STATE SIGNIFICANT DEVELOPMENT ASSESSMENT

ACCESSIBILITY REPORT

Project: 15-21 Cottonwood Crescent, Macquarie Park
Document Type: State Significant Development Assessment
Our Reference: P2025_0402-2 (SSDA) YW & DC

Figure 4 – Principal and secondary pedestrian and vehicular access

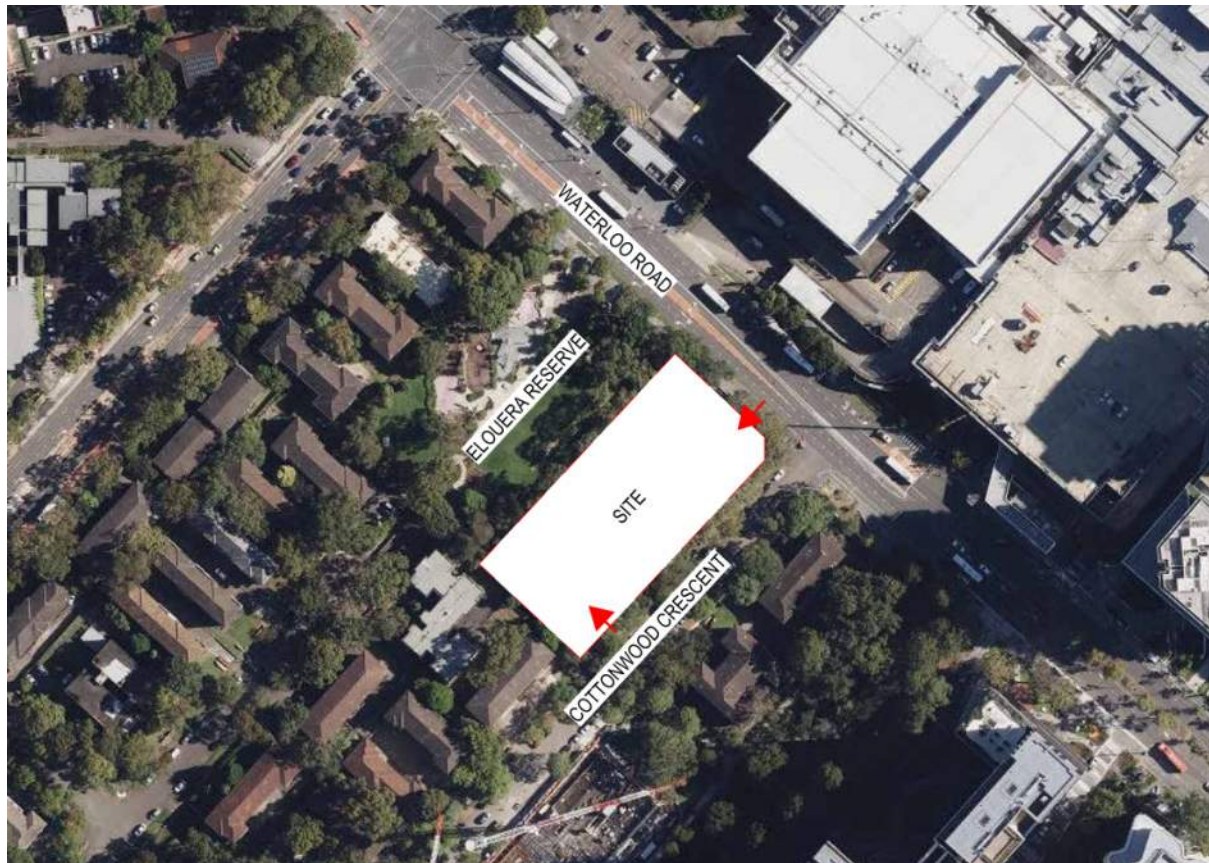
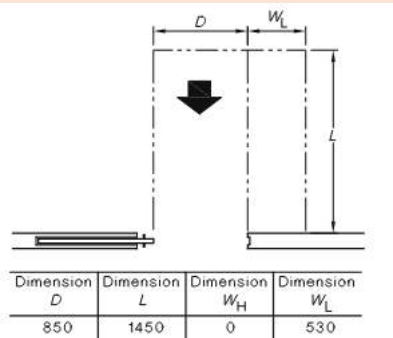
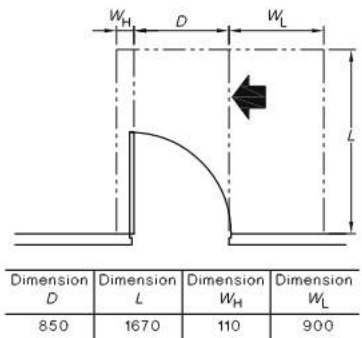
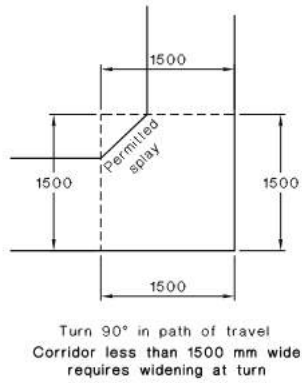
The overall provision is capable of meeting the code requirements. The following comments are provided in regards the requirements of Clause D4D2 of the NCC—

DESCRIPTION	COMPLIANCE DEPARTURE	RESOLUTION
Upper Ground Townhouses	Direct pedestrian access from the allotment boundary to the main entrance of the Class 2 townhouses is required under NCC D4D2(4)(a). 	At the time of review, pedestrian access to the Class 2 townhouses located at Upper Ground is not provided. This departure is required to be addressed by a Performance Solution.

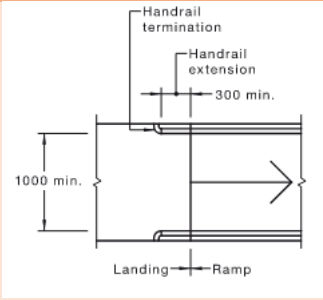
A swimming pool is proposed at Level 4 with a perimeter of 50 metres. In accordance with the NCC and Premises Standards, at least one accessible means of entry to the pool is required.

DESCRIPTION	COMPLIANCE DEPARTURE	RESOLUTION
Swimming pool (Level 4)	A swimming pool is proposed at Level 4 with a perimeter of 50 metres. In accordance with the NCC and Premises Standards, at least one accessible means of entry to the pool is required. Given the vertical travel distance to the pool level exceeds 1000 mm, the following options may be considered: • Provision of a veridical stairway platform lift to facilitate universal access to the pool level (Performance Solution); or • Provision of a stairway platform lift: and • Provision of a zero-depth entry at a maximum gradient of 1:14, together with an aquatic wheelchair.	Further details are required to demonstrate compliance or to support a Performance Solution. These matters will be addressed as the design progresses.
